**Addendum No. 2  
January 19, 2024**

Project: **Lennox High School Addition**  
Lennox, South Dakota  
Architecture Incorporated Project No.: 2982

Architect: Architecture Incorporated

## FLOOR PLAN - AREA E

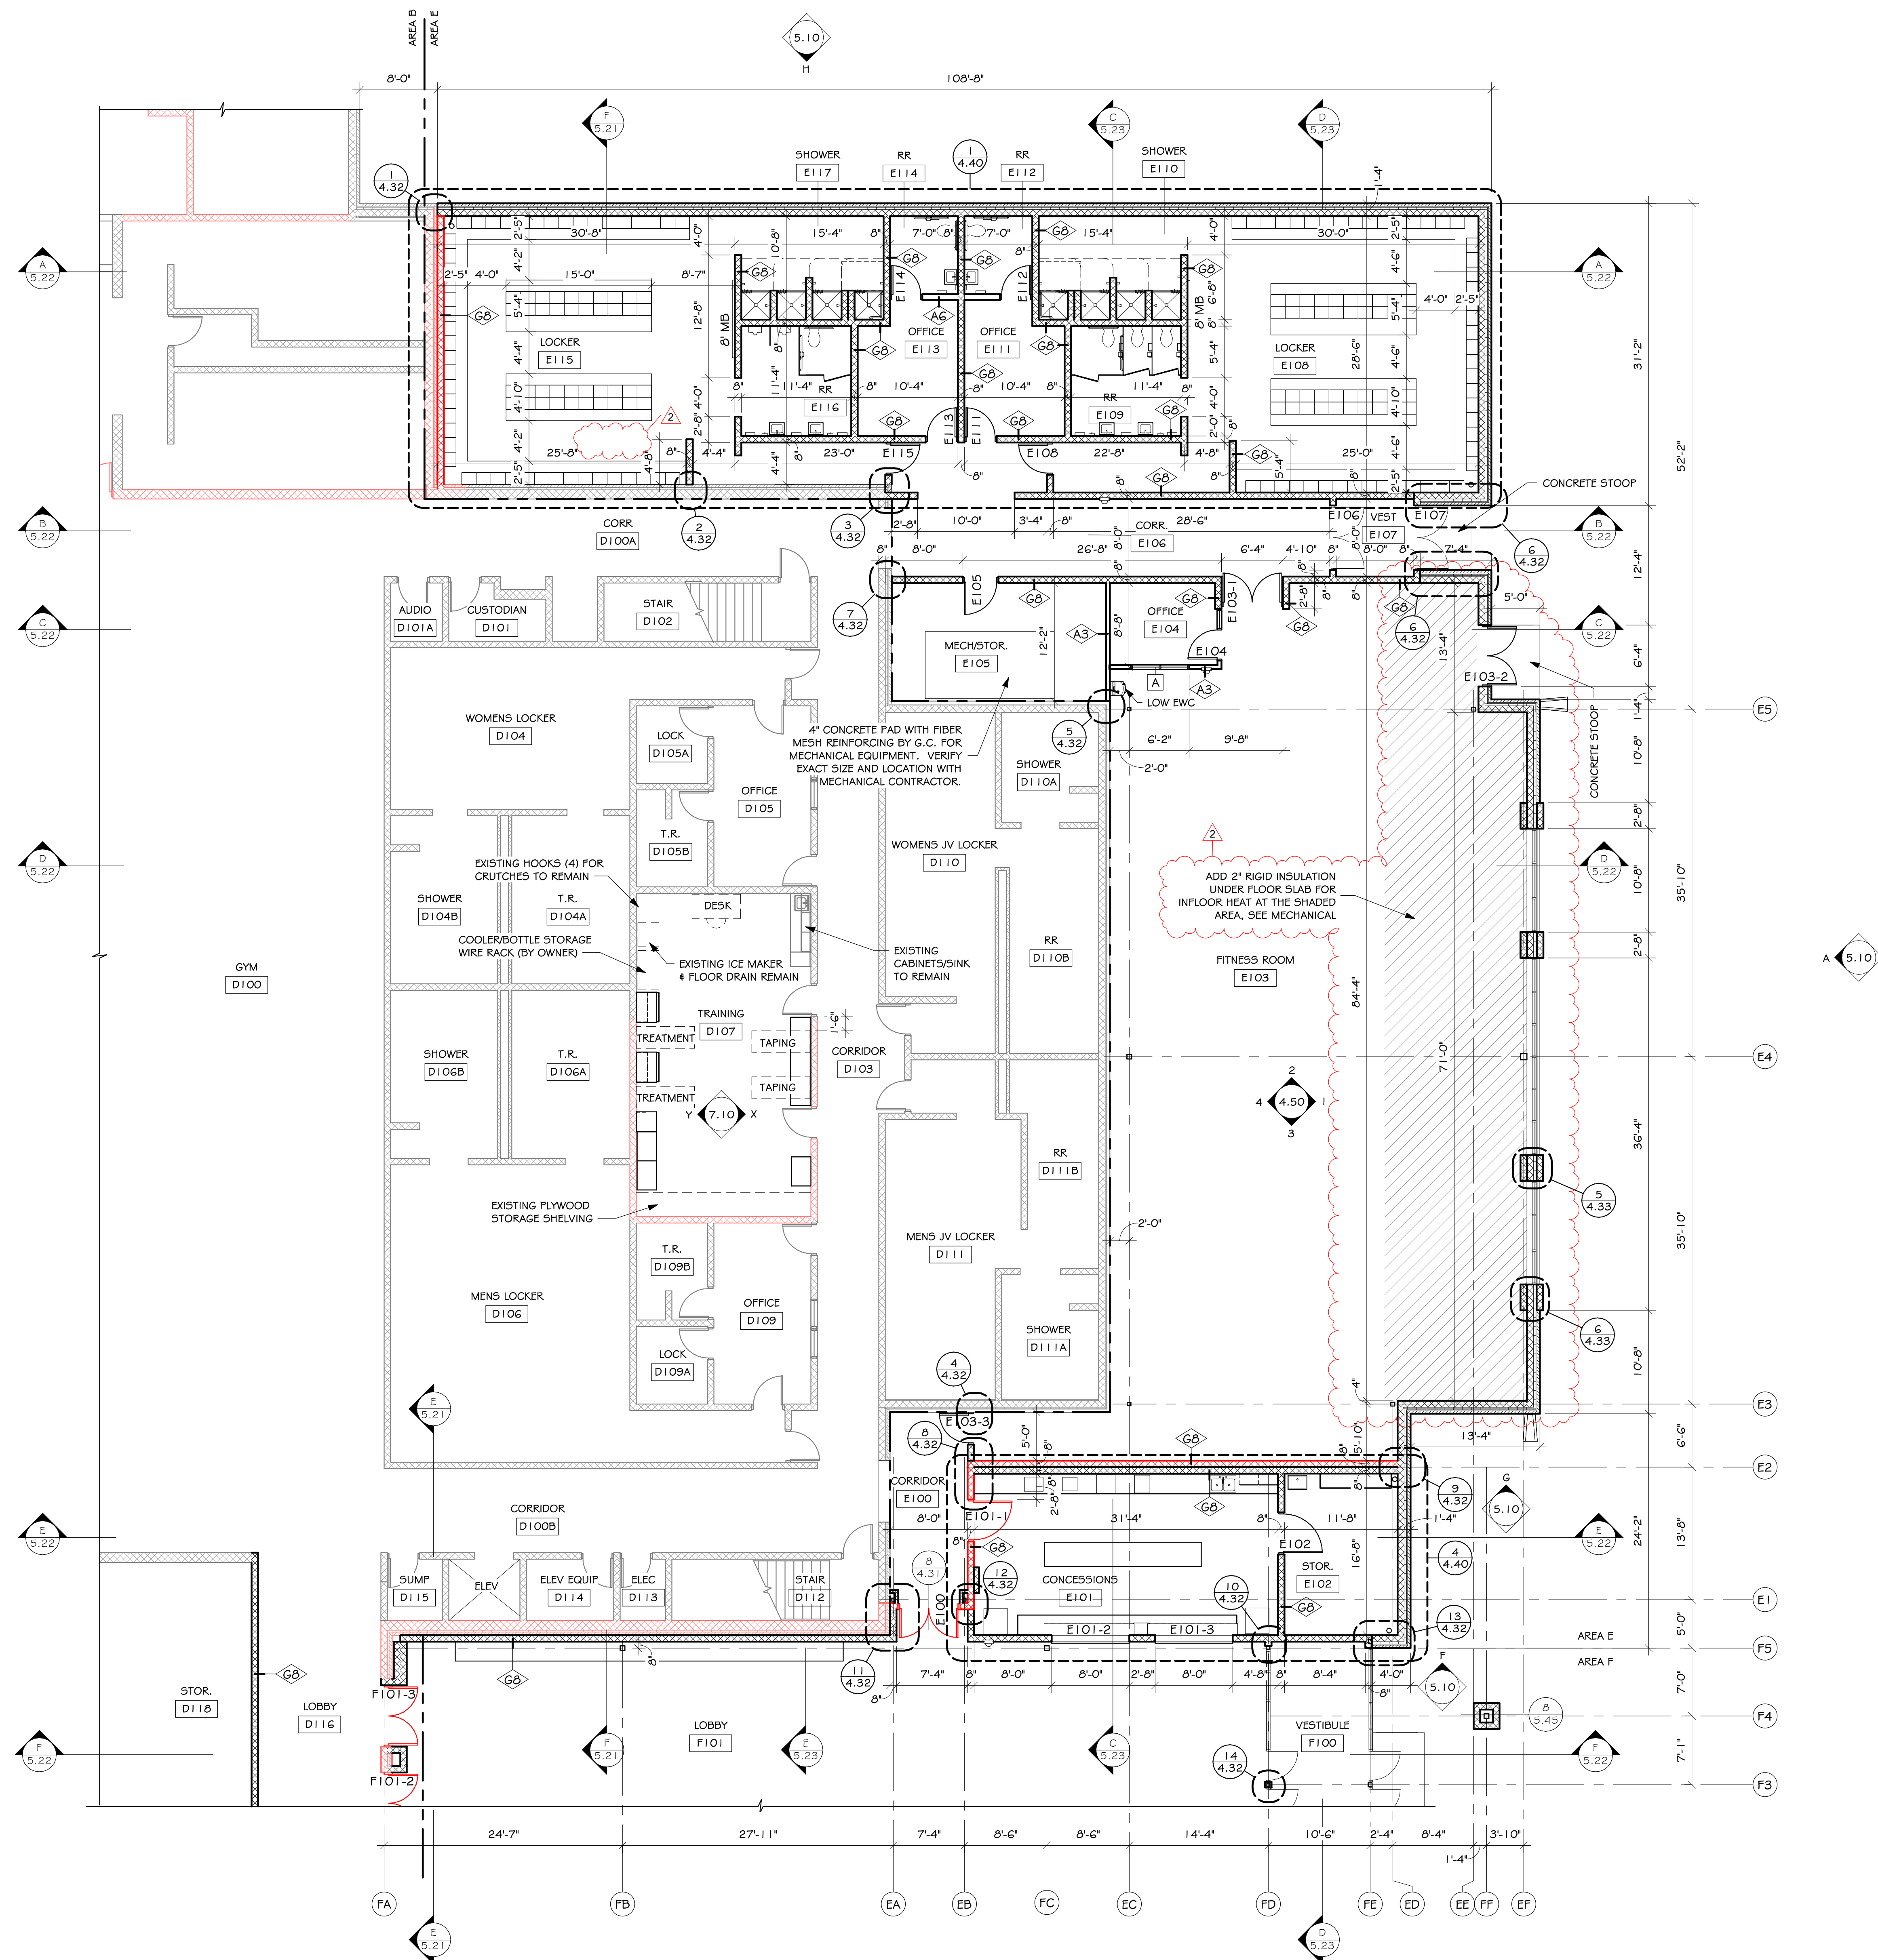
18) SHEET 4.10-E – FLOOR PLAN – AREA E

- a) Reference *revised* drawing Sheet 4.10-E, dated 1-18-24, attached to the end of this addendum for following:
  - i. Locker Room E115, omit note regarding 87 lockers. Provide locker quantity as shown.
  - ii. Provide 2” of rigid insulation beneath the concrete floor slabs at all in-floor heat locations in Fitness Room E103, Lobby F101 and Vestibule F100 as shown on attached drawing 4.10-E.

### FLOOR PLAN - AREA F - BASE BID

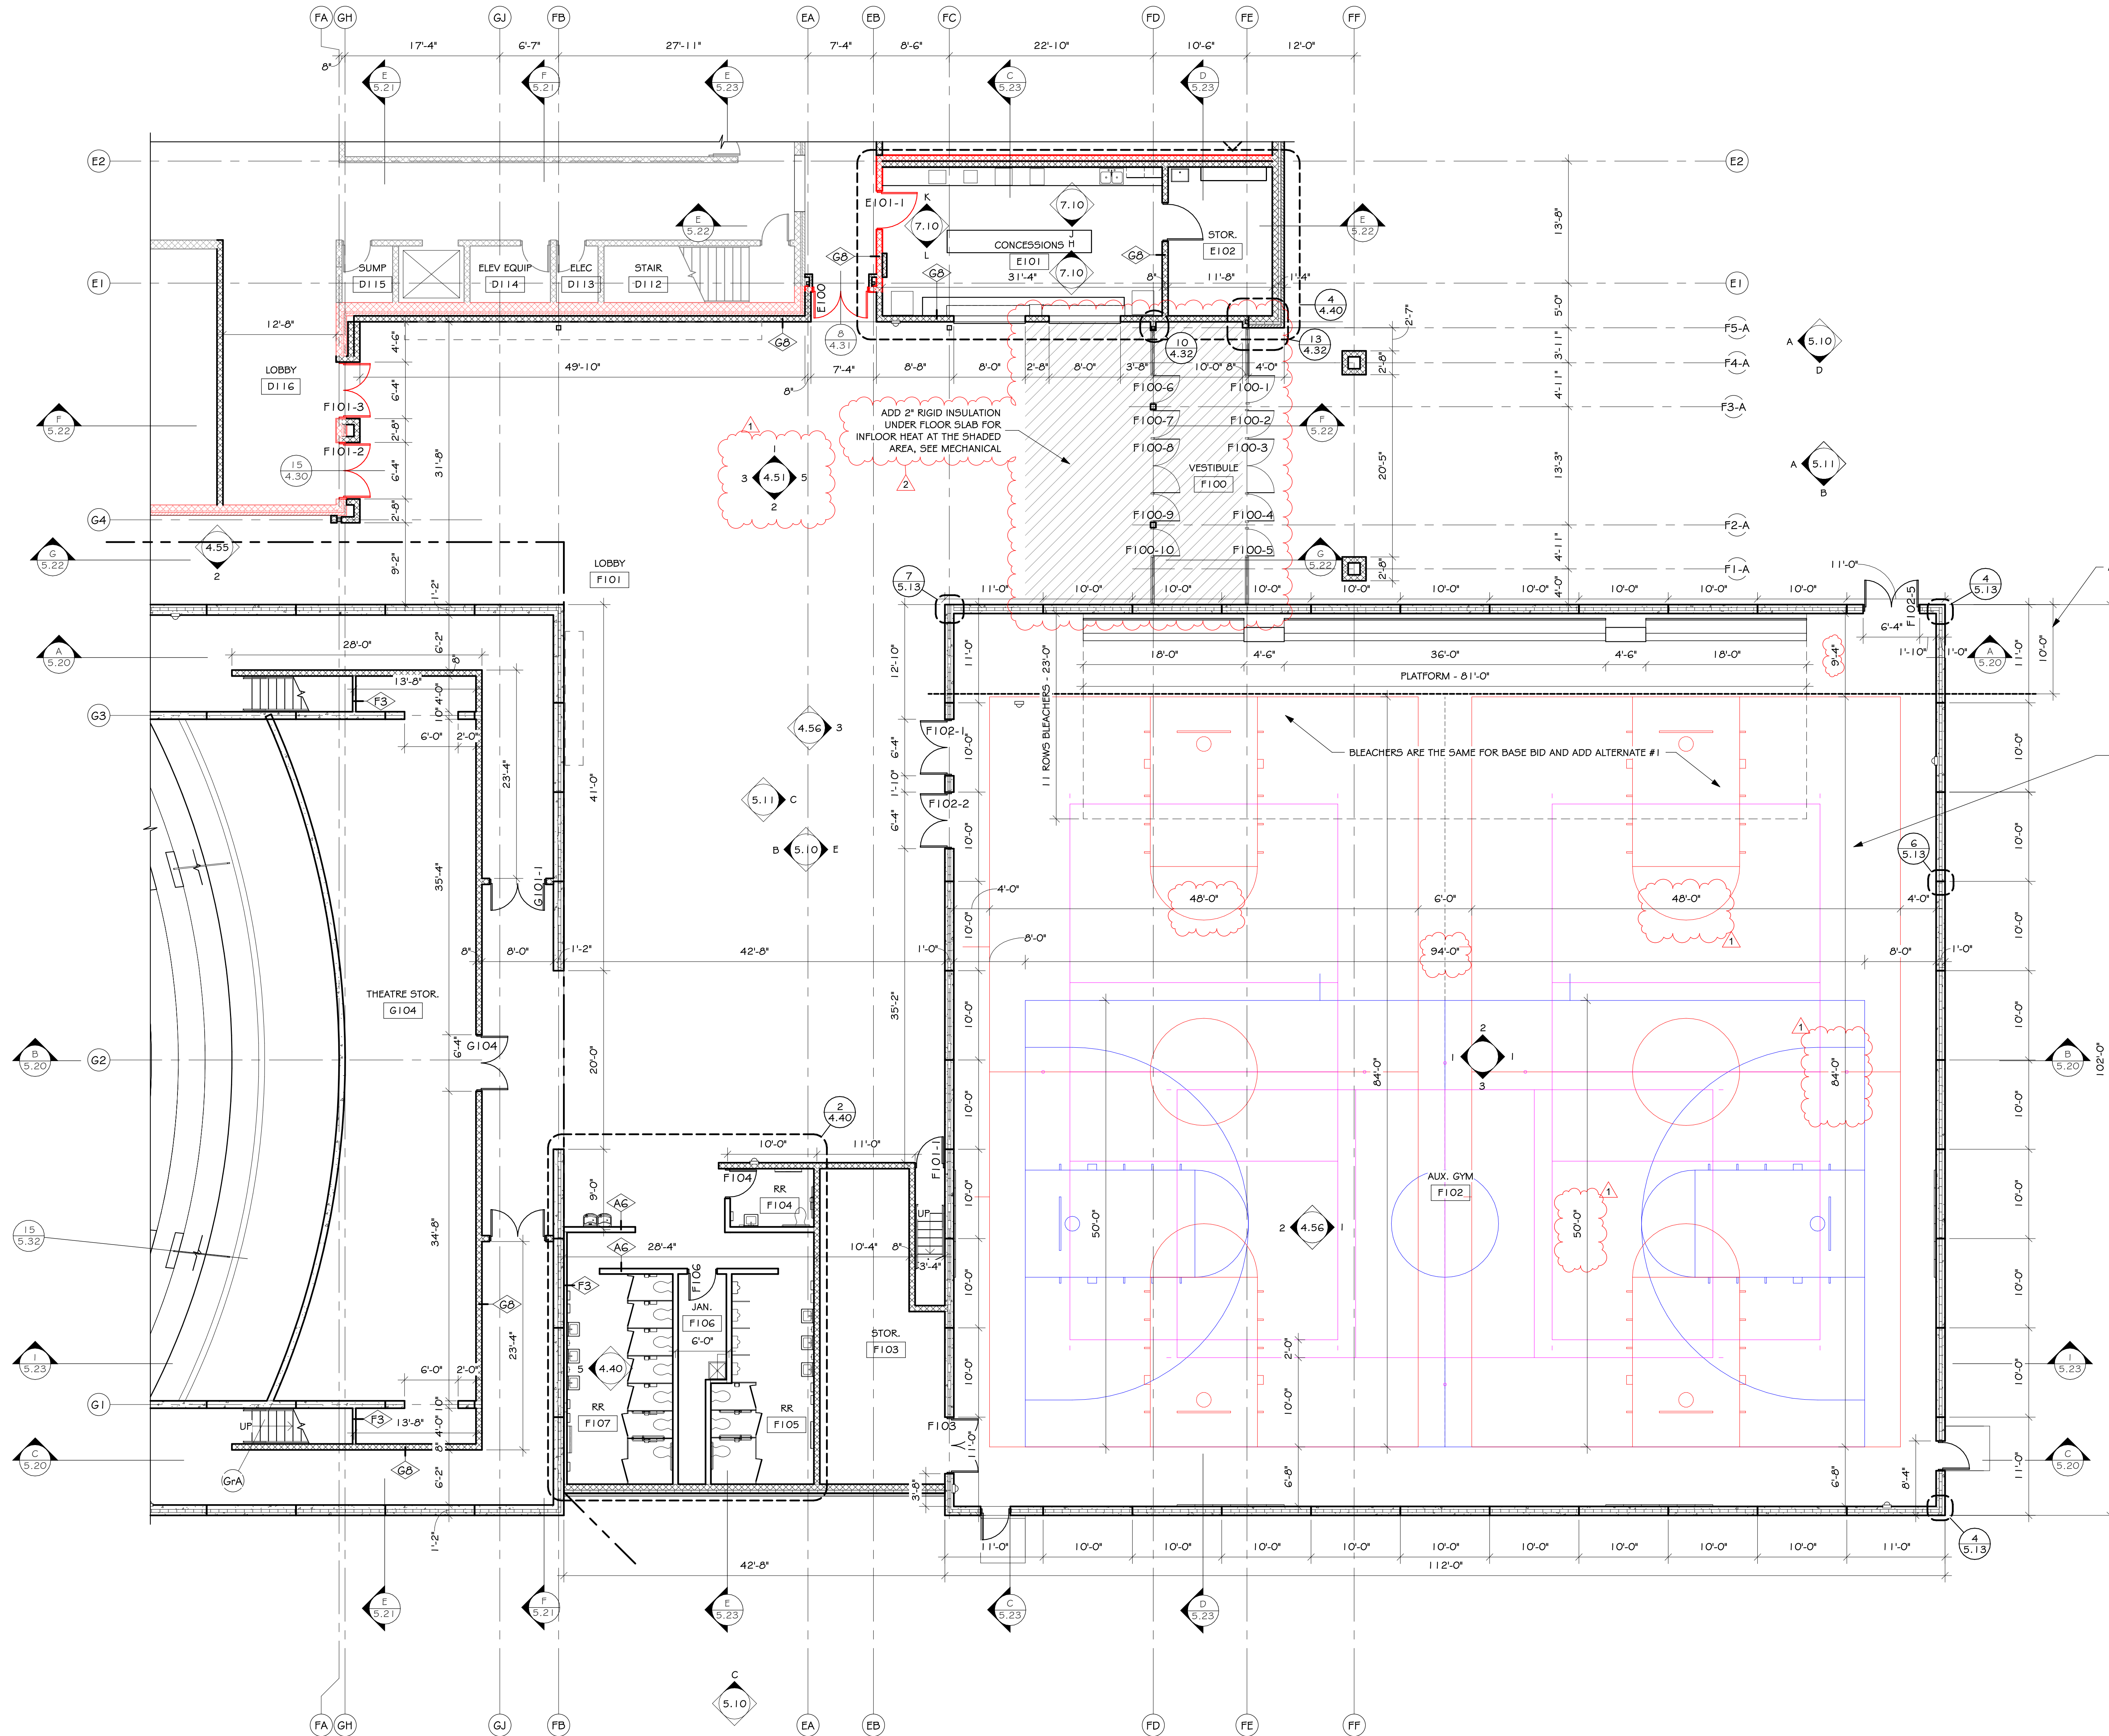
19) SHEET 4.10-F – FLOOR PLAN – AREA F – BASE BID

- a) Reference *revised* drawing Sheet 4.10-F, dated 1-18-24, attached to the end of this addendum for identification of floor slab areas in Lobby F101 and Vestibule F100 that shall be provided with under-slab insulation.
